CITY OF ALBUQUERQUE

**Re: GAHP Casa Feliz
421 Espanola Street SE
Requested for Permanent C. O. – Not Accepted
Engineers Stamp Date 12/18/15 (L19D073F)
Certification dated: 6-7-17**

PROJECT TITLE: GAHP Casa Feliz (L19D073F)

Trapezoidal

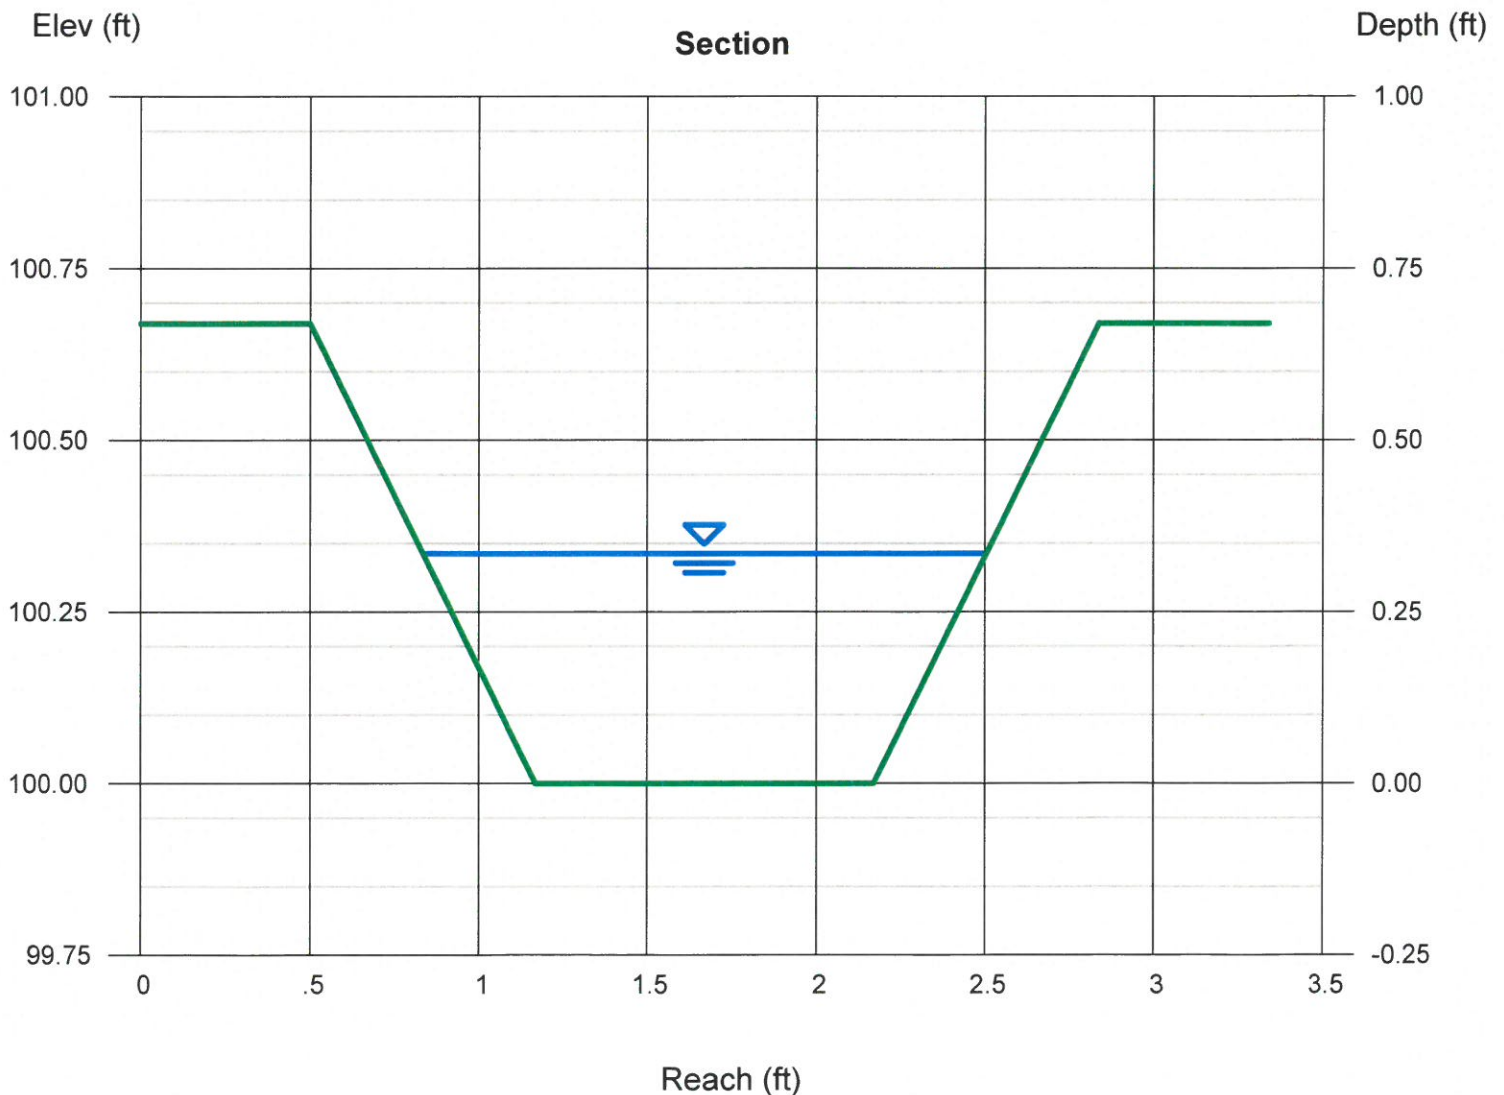
2. The calculations for the pipe and side yard swale need to be revised and constructed to prevent cross-lot drainage. The pipe should be analyzed as a culvert instead of the normal depth calculation in 6-28-2017 submittal. The headwater depth on the 12" culvert is about 0.9'. Manning's "n" value in the channel calculations also needs correction from 0.025 to 0.045 for rip-rap.

3. Using the revised capacity calculations please provide a swale with at least 4" freeboard to insure that drainage from this site will not enter the adjacent property. The adjacent site is particularly susceptible to flooding so please make sure that no drainage from this site will enter that property.

A1 ENLARGED SITE DRAINAGE PLAN - BUILDING H

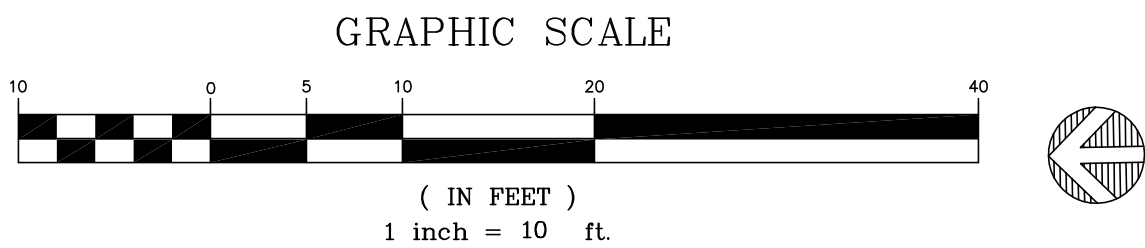
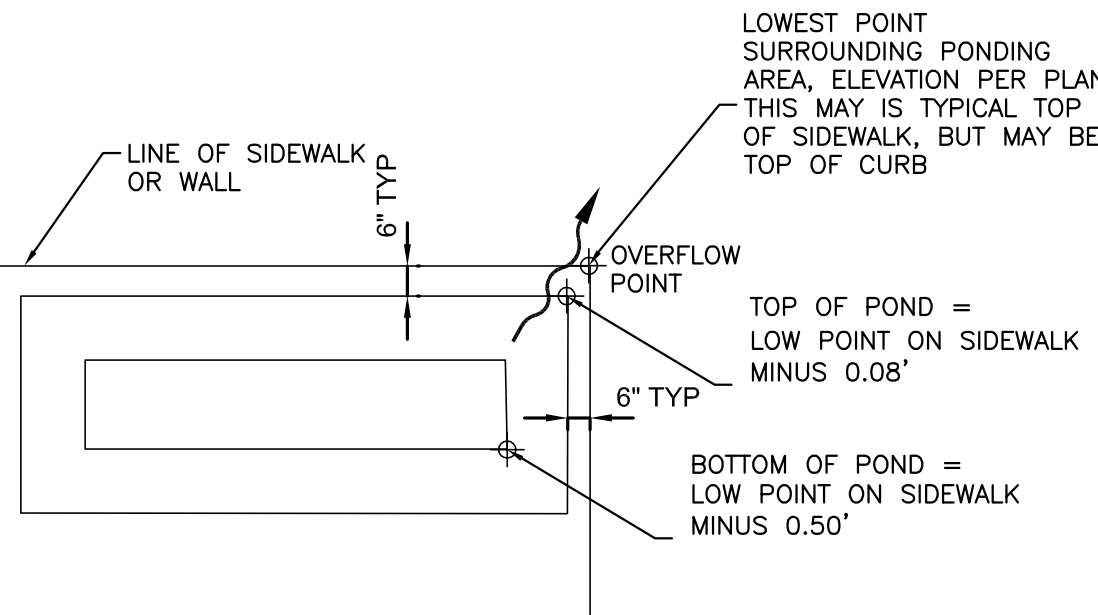
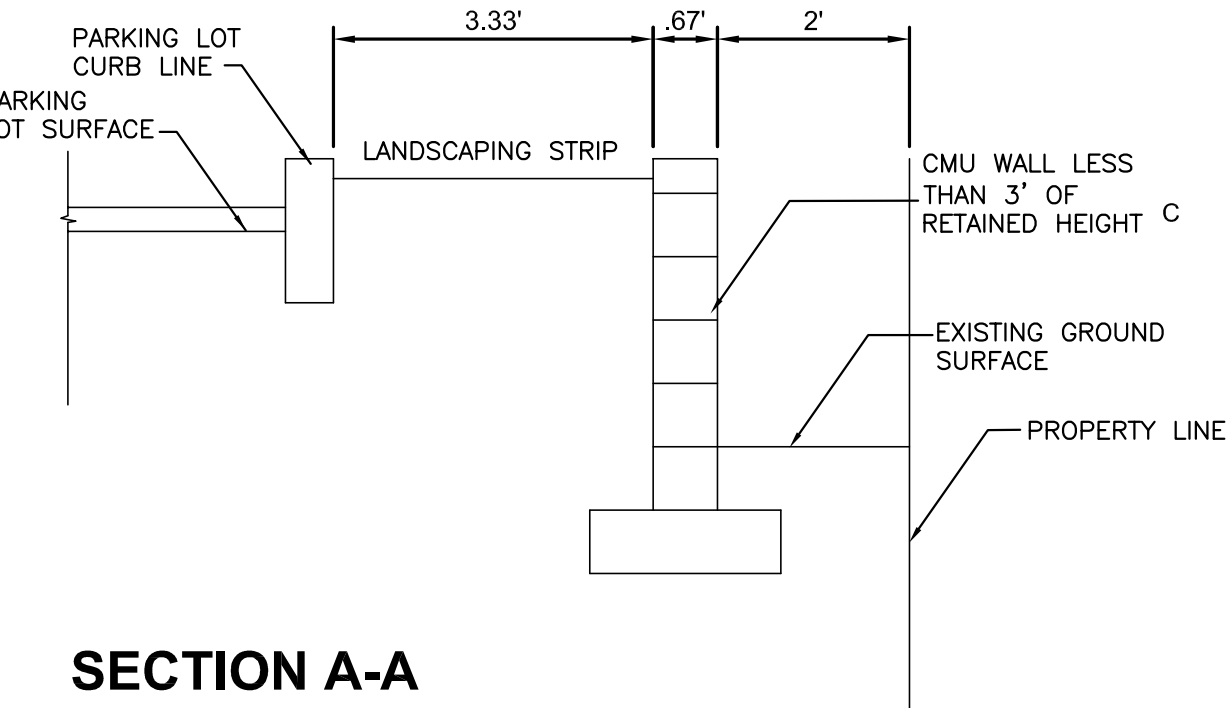
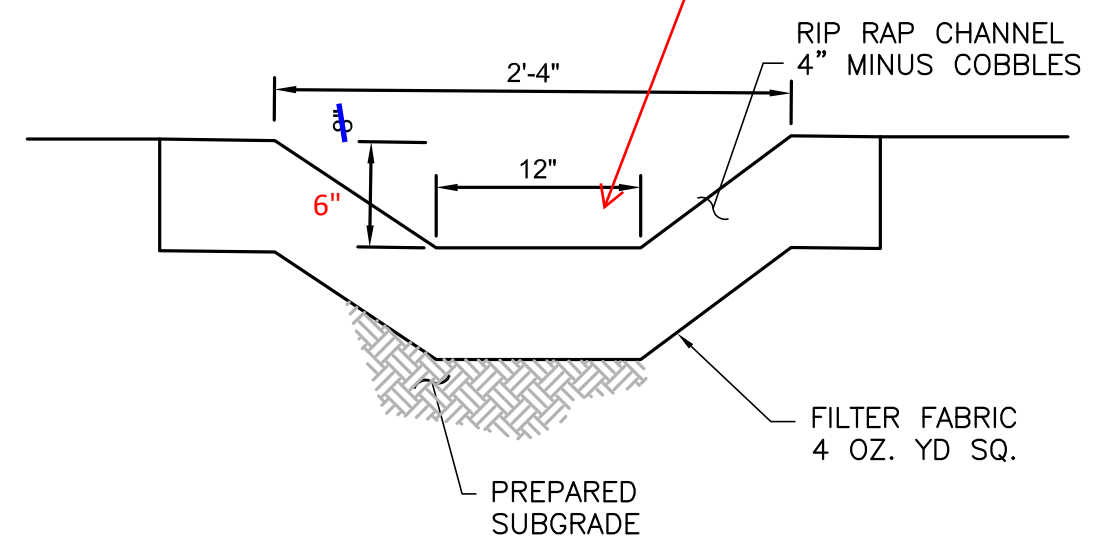
1. The swale on the south side of the site is inadequate to prevent cross-lot drainage and this project placed about 1' of fill along the property line piled against a wooden fence. A retaining/flood wall is recommended to prevent drainage from entering the adjacent lot.

Please revise the calculations and add a flood wall or something on the property line to accomplish the grade change and prevent cross-lot drainage.
